**Affected Product** 10103 - Cable IEEE 1394a 4.5m  
**PCN Title** Replacement 10103 Cable IEEE 1394a 4.5m  
**PCN No.** 2018-11-02 **PCN Issue date** 2019-01-16

10103 - Cable IEEE 1394a 4.5m

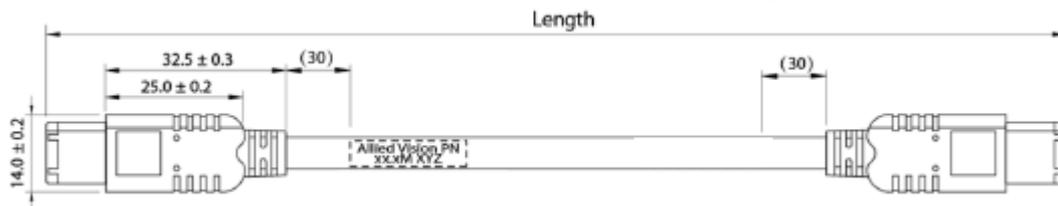
Cable material of cable 10103 has been obsoleted and replaced by the supplier.

The cable 4.5m 1394a cable 10103 is not available any longer. The item will be replaced by a new item 13737. The new cable has the same connector and properties, as shown in the image below:

specification	Cable 10103	Cable 13737
Length	4.5m ± 75mm	4.5m ± 100mm
Diameter	6.1mm	5.7mm

The cable 10103 is replaced by cable 13737 with immediate effect.

None. Orders will automatically be converted to the new order code.
